Access Compliance Report

Public Rights-of-Way

(Curb Ramps)

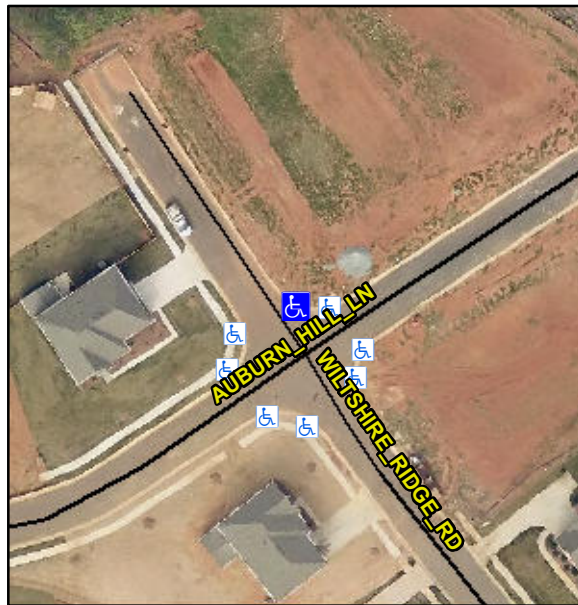
Intersection ID: 49130	Main Street: AUBURN_HILL_LN	Cross Street: WILTSHIRE_RIDGE_RD	Location:	N
ADA ID: 703C3578DE81	Ramp Type: Perp	Initial Pass/Fail: Fail	Overall Compliance: No	Severity Score: 8.75
Codes/Mitigation Info/Possible Solution		Field Measurements/Component Compliance

Not Found, R304.5.1

Compliance	Description	Data	Compliance	Description	Data
N/A	Ramp Length (in)	48.0	Yes	Ramp Slope (%)	7.4
No	Ramp Width (in)	47.5	Yes	Ramp XSlope (%)	1.2
N/A	Flare Type LT	N/A	N/A	Flare Type RT	N/A
N/A	Flare Slope LT (%)	N/A	N/A	Flare Slope RT (%)	N/A
N/A	Flare Traversable LT?	N/A	N/A	Flare Traversable RT?	N/A
N/A	Landing Length (in)	N/A	N/A	DWS Provided?	N/A
N/A	Landing Width (in)	N/A	N/A	DWS Contrast?	N/A
N/A	Landing Slope (%)	N/A	N/A	DWS Length (in)	N/A
N/A	Landing X Slope (%)	N/A	N/A	DWS Full Width?	N/A
N/A	Landing Curb? (Y/N)	N/A	N/A	DWS Offset (in)	N/A
N/A	Shared Landing?	N/A			
N/A	Gutter Ponding?	N/A	N/A	Gutter Slope (%)	N/A
N/A	Gutter Lip Ht (in)	N/A	N/A	Gutter X Slope (%)	N/A
N/A	Painted X Walk1?	No	N/A	Painted X Walk2?	N/A
	X Walk 1 Direction	To SW		X Walk 2 Direction	N/A
N/A	X Walk 1 Width (in)	N/A	N/A	X Walk 2 Width (in)	N/A
	X Walk 1 Slope (%)	1.2		X Walk 2 Slope (%)	N/A
	X Walk 1 X Slope (%)	0.9		X Walk 2 X Slope (%)	N/A

Remove & Replace Entire Ramp.
